RotorSport UK Ltd Service Bulletin

Title: Pre-rotator bendix shaft retention		
SB No.: 086 Iss1	Related documents MC No: None CCAR No.: 060	Compliance Category: OPTIONAL or RECOMMENDED or MANDATORY
Applicability		
Aircraft type & model: MTOsport, Calidus, Cavalon MT-03	Aircraft serial Nos. affected: Any a/c manufactured before 7/14 If a replacement bendix shaft has been fitted since original build.	
This form is the response from RotorSport UK Ltd either against a problem found in the product in service requiring a containment or rectification action, or as service information for aircraft modification incorporation. For help, contact RotorSport on 44(0)1588 650769, or email info@rotorsport.org.		
<p><u>Reason and overview of the Service Bulletin (cause of problem if known)</u></p> <p>Analysis of incident reports made to Auto-Gyro has found that pre-rotator bearings may fail due to wear/debris resulting from the pre-rotator bendix shaft turning in the upper bearing's inner race. This may be evidenced by an uneven wear pattern on the ring gear. Use of Loctite 638 Retainer when assembling the shaft into the bearing eliminates the design clearance (for assembly) between the two, and

Fig. 1 - Wear Pattern (uneven)

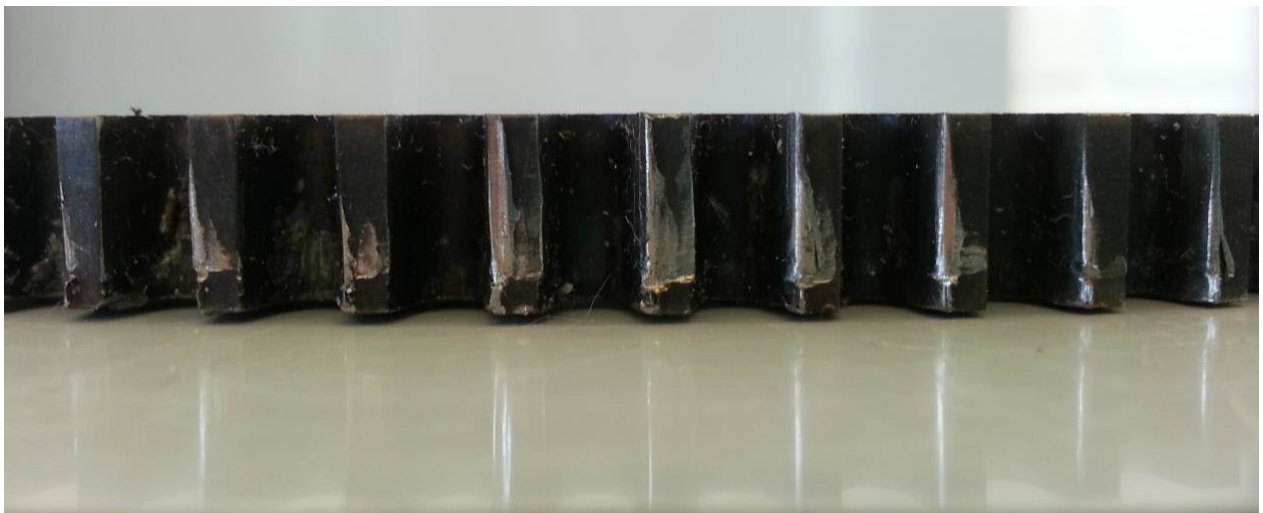
- 1 Inspect the wear pattern and gear mesh of pre-rotator upper engagement.
- 2 If the wear pattern is uneven (see Fig. 1) the condition of the bendix shaft must be inspected, otherwise this is optional. Remove the lower bearing (see relevant AMM) and ensure that the shaft is, in the free load condition, centrally positioned in the bearing seating. If free play in the upper bearing is present, the following must be carried out:

- 3 **Free play due to bearing abrasion:** Replace upper bearing (see relevant AMM) and on re-assembly retain the bendix shaft with Loctite 638 into the upper bearing. Reassemble lower bearing.

- 4 **Free play due to abrasion of the bendix shaft by the ball bearing inner ring:** On re-assembly retain the bendix shaft with Loctite 638 into upper bearing. Reassemble lower bearing.
If free play is greater than 1/10 mm, then replace the bendix shaft with a new part and retain in the upper bearing with Loctite 638.
